Addressing variability of test fixtures (comment #85)

Adee Ran, Cisco

Cl 179B	SC 179B.4.1	P912	L10	# 85
---------	-------------	------	-----	------

Figure 179B-2—Mated test fixtures insertion loss

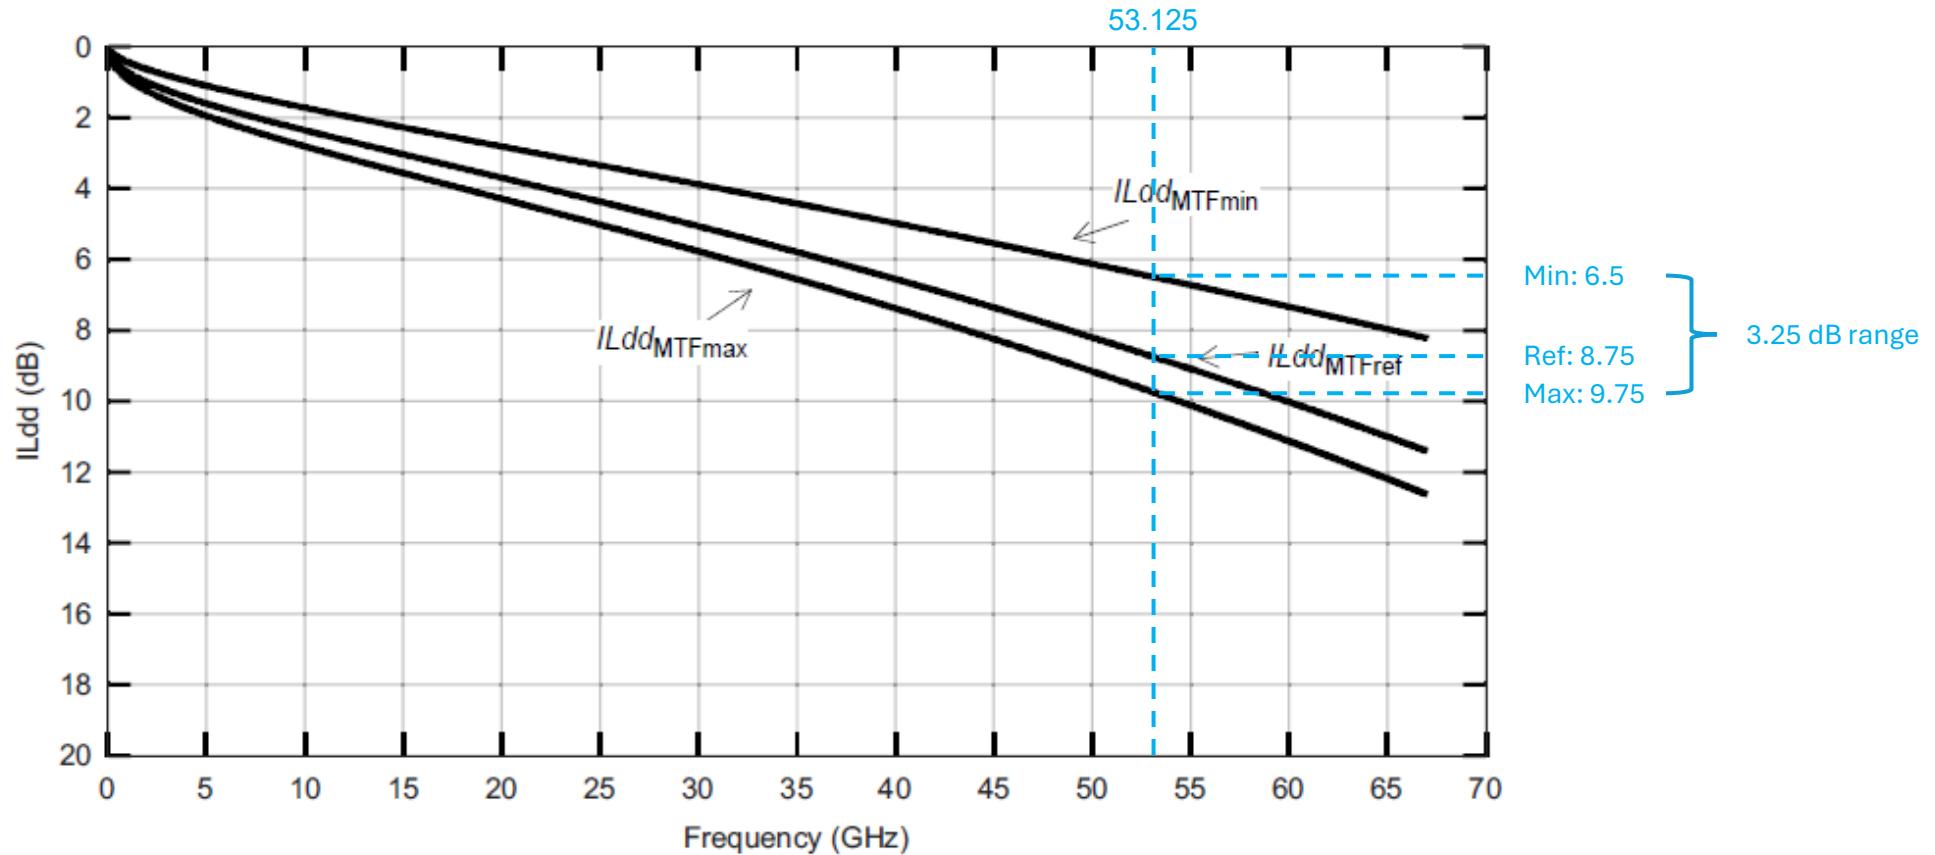
Illd_MTFmin is, at fNyquist, 4dB lower than Illd_MTFmax. This large allowed variation in MTF IL introduces too much uncertainty as to whether a given DUT (host or cable assembly) passes or fails due to variation in the test fixture.

The difference between minimum and maximum Illd for mated test fixtures is about 3 dB at the Nyquist frequency.

This difference allows significant variations in cable assembly test fixture (MCB), which can have a double effect (up to 6 dB) if used to measure a cable.

Reduce the allowed variability of test fixtures, or its effect on measurements. A detailed proposal is planned.

Decrease the spread between IlldMTFmin and IlldMTFmax to ~2dB, by adjusting equations 179B-3 and 179B-4.

The comment identifies an area for potential improvement in the current draft. However, the suggested remedy does not provide sufficient detail to implement.

MTF measurement data

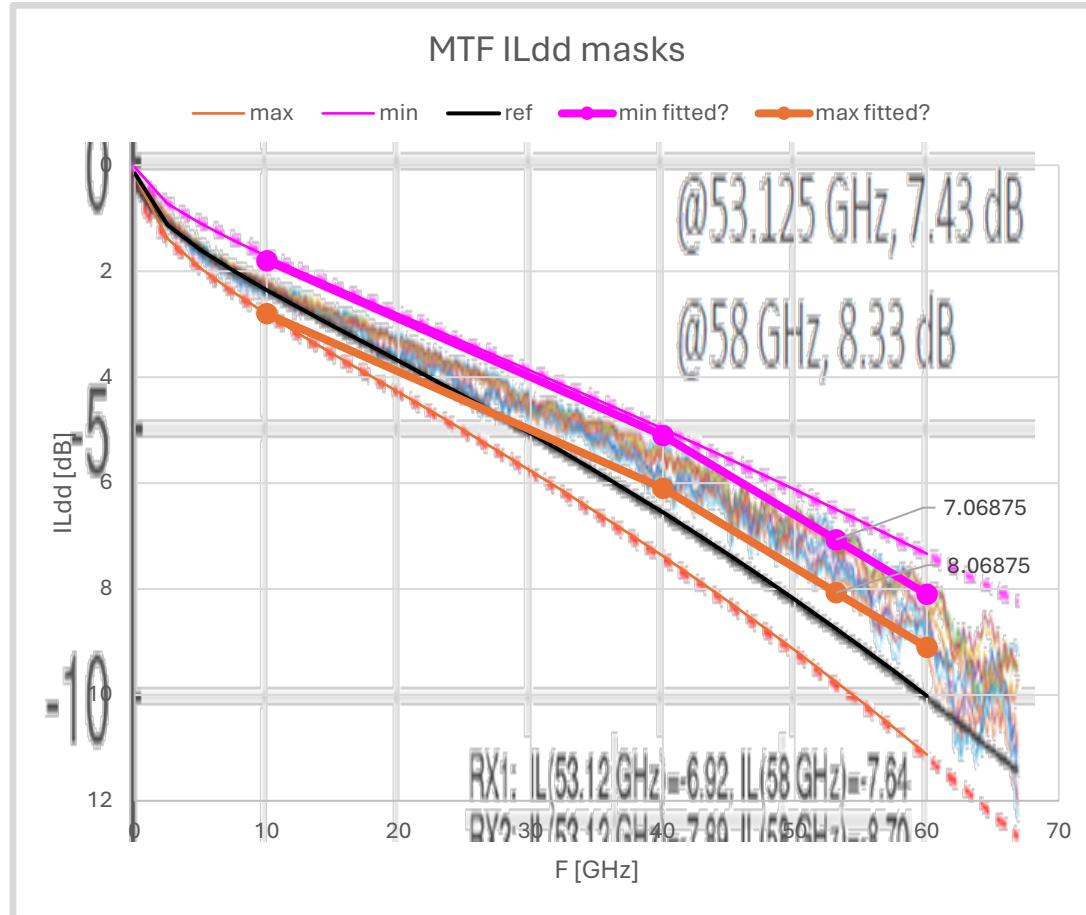
Variation between lanes on the same MTF is significant – at 53.125 GHz, 0.98 dB for “connector #1”, 0.69 dB for “connector #2”. There is a larger variation above 53.125 GHz

The differences seem mainly in the ripple.

The range can be tightened somewhat by raising the “max” line (and the reference line)...
But this might coincide with manufacturing variations and yield

Mask overlaid on “MTF with Connector #1” plots

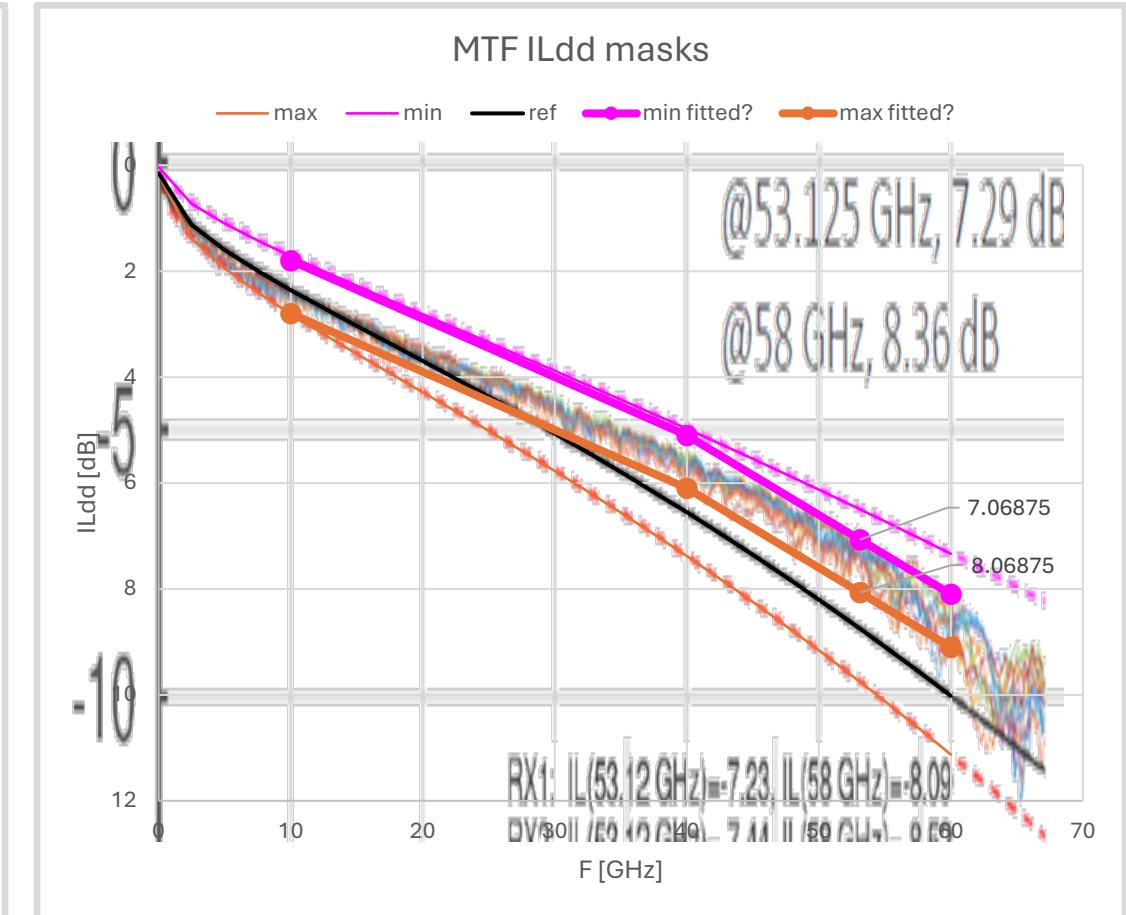
- This is an addition we can make quickly... but
 - It is tailored for this dataset – maybe not suitable for other designs
 - It does not solve the “combinations of fixtures” issue
 - It does not solve the “accounting for difference” issue
 - The reference ILdd is not within the mask...
- Not a complete solution
 - But mentioned here in case people want to check it

- One direction is to reduce variability, but without causing actual test fixtures to fail
- Since the ripple is limited by another specification (FOM_{ILD}) we can apply a tighter mask to the **fitted ILdd** (which should be less variable)
- The following piecewise-linear equations (with ± 0.5 dB tolerance) create a possible mask based on the Mammenga dataset:
 - Min fitted ILdd:
$$\begin{cases} 1.8 + 0.11(f - 10) & 10 < f \leq 40 \\ 5.1 + 0.15(f - 40) & 40 < f \leq 60 \end{cases}$$
 - Max fitted ILdd:
$$\begin{cases} 2.8 + 0.11(f - 10) & 10 < f \leq 40 \\ 6.1 + 0.15(f - 40) & 40 < f \leq 60 \end{cases}$$
- Visualized on the next slide
